## CHAPTER 5

### TRANSPORTATION ACCIDENTS

**Figure 5-1. Accident frequencies in the U.S. from 1991 until 2007**

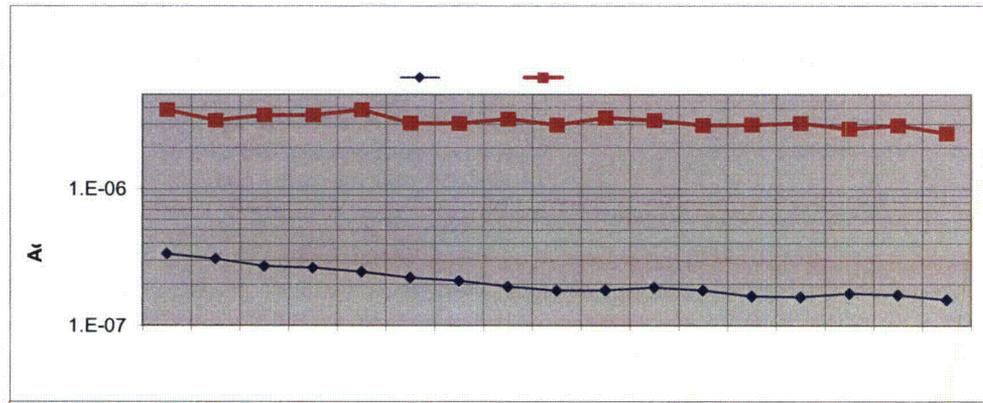
**Comment [h4]:** I think this is a typo, the value should be 6.8e-7 based on the values listed here

**Comment [csb5]:** I'm afraid that these numbers are not going to mean much to the uninitiated reader.

**Comment [csb6]:** Is this for ALL rail (i.e., passenger and freight) or for just freight rail? This needs to be clarified. Using freight rail numbers makes more sense, using HAZMAT transport numbers is probably the most realistic.

**Figure 5-2. Radiation dose for one hour to the maximally exposed individual (MEI) from loss of lead gamma shielding at distances from one to five meters from the cask carrying spent fuel.**

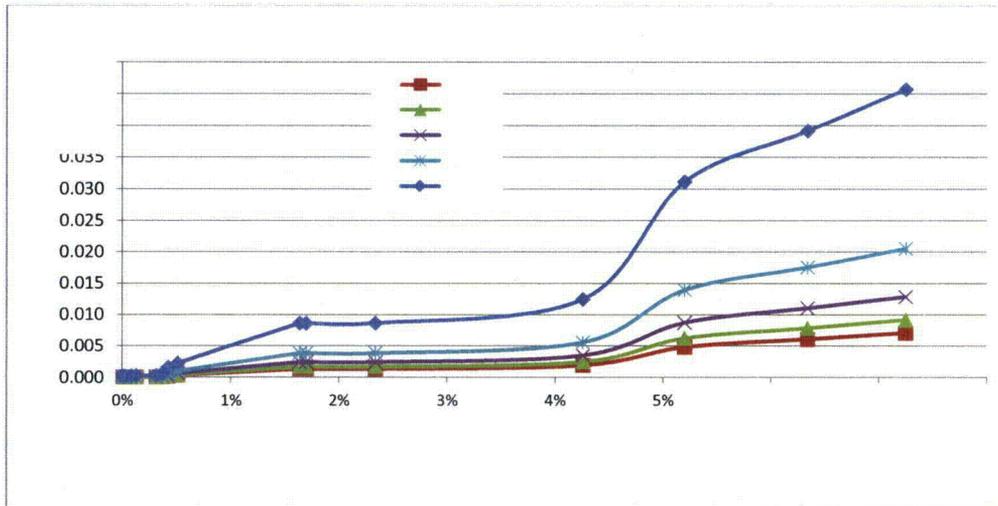
**Comment [h19]:** The results for the 1m case look suspicious compare to the other runs. An example calculation using the 1m distance would be useful and serve as a good check on these results.

**Comment [s20]:** I am not sure I concur with the accuracy of Fig 5-2 based on the dose trends that are shown and the rather cursory model explanation of Appendix V.3.1? ORNL will do more work to confirm accuracy or illustrate / document inconsistencies based on independent modeling (see comment S8 in Appendix V).

**Comment [s21]:** It would seem valuable to point the reader to the model used for these analyses as described in Appendix V.3.1? (CParks)

**Figure 5-4. Air (a) and ground (b) concentrations of radioactive material following a release**

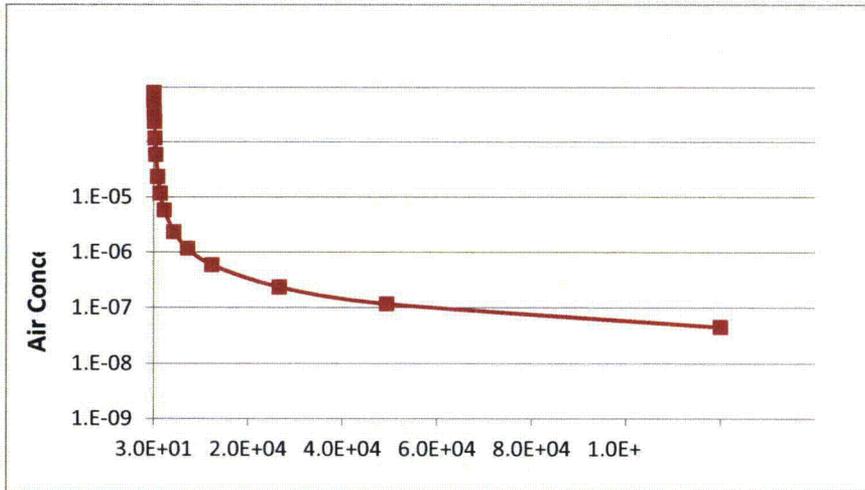
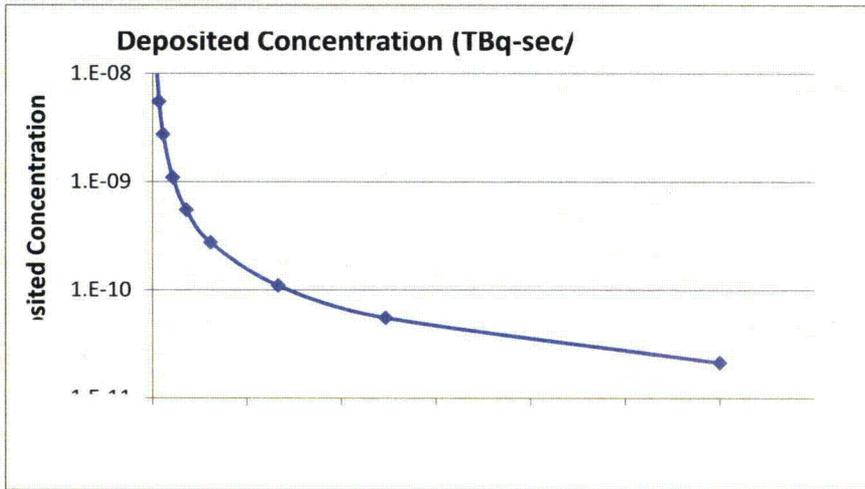
**Comment [h44]:** Include example RADTRAN calculation for one of these cases

**Comment [h45]:** Include example RADTRAN calculation for one of these cases

**Comment [MF46]:** Note that the most of the x-axis is linear, but the first number (on left) appears to be logarithmic. The first number should be 0. This applies to both a and b.
